Shoreland Permit Applicationfor a **Shoreland Protection Permit** under Chapter 49A of Title 10, § 1441 *et seq.***For Shoreland Permitting Use Only**Application Number: **226**VERMONT DEPARTMENT OF
ENVIRONMENTAL CONSERVATION

Re: Michael & Rebecca Abbott- 719 Hills Point Road-Charlotte,VT
Shoreland Permit Application for Proposed House Reconstruction Project

From: Cetner, Misha [<mailto:Misha.Cetner@vermont.gov>]
Sent: Wednesday, December 02, 2015 2:18 PM
To: karen.bresnahan@fourseasonssir.com; rebeccametz15@gmail.com
Subject: Shoreland Permit Application #226 Updates

SITE PLAN - 119 HILLS POINT ROAD CHARLOTTE

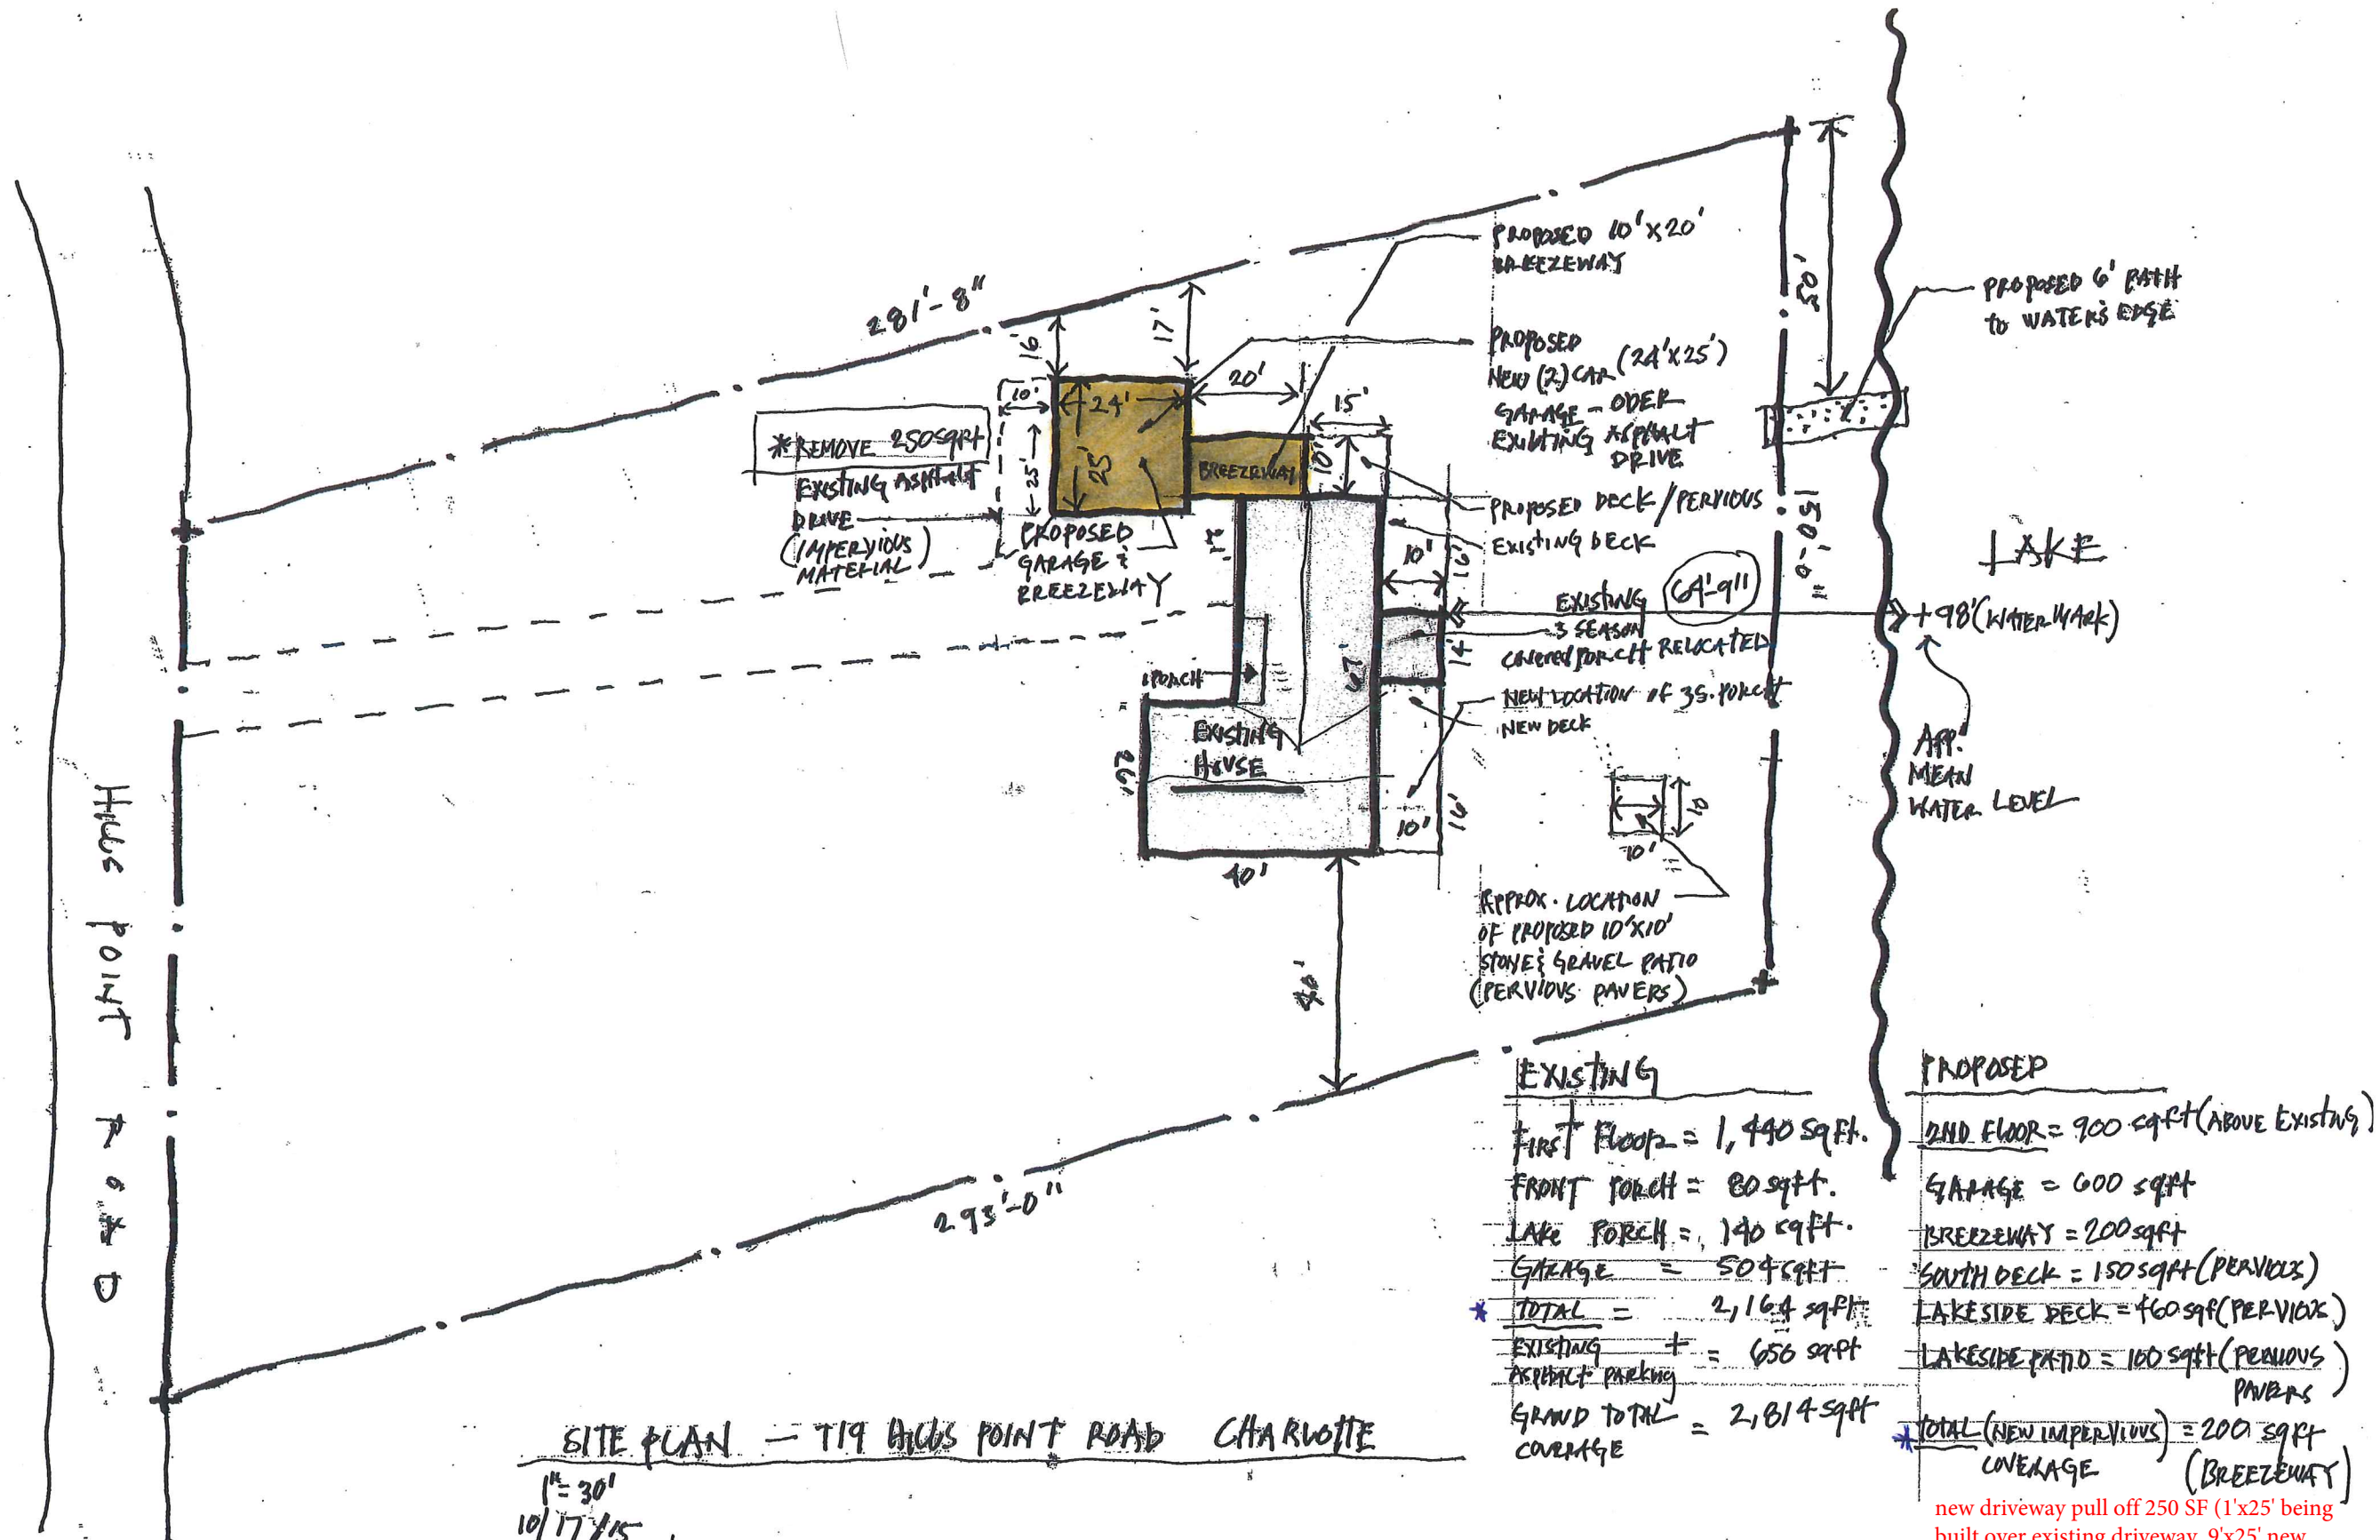
new driveway pull off 250 SF (1'x25' being
built over existing driveway, 9'x25' new
impervious surface 225 SF)

- The distance the current structure is to the 95.5' elevation mark of Champlain.
- The distance between the new impervious surface and the 95.5' elevation mark.
- Clarify what the new impervious surface is and how that number was obtained. The number on the site plan is different from the number on the application.
- Identify the surface area of vegetation (the one 12" diameter tree) that will be removed.
- If you're replacing impervious surfaces with pervious designs, could you provide one number identifying the total impervious surface that will be on the parcel after completion of the project? Also, could you provide a description of the pervious deck design?

Total new impervious surface 425 SF

New SQ FT	Replacement of Existing SQ FT
New Impervious		
New Breezeway 10' X 20'	200	
New Garage 24' X 25'	600	
New Pull Off 10' X 25' 9'x25' of new; 1'x25' over existing impervious*	250	225 SF of new impervious*
Less Removal of Existing Pull Off 25' X 25'		-625
Less Gain of Old Deck Impervious w/New Design		-160
Totals	-1050	-785
Total New Impervious (New less replacement)	-265 425 SF

I think I have clarified the new pervious in the attached, sorry for any confusion. Also the town wanted measurements at 98' from the MWL. You are asking for measurements at 95.5 ' from the MWL. I think we can resolve that by adding the difference 2'6" to all the existing measurements. See below and let me know if this help clarify your questions. I can see why there was confusion—very sorry!
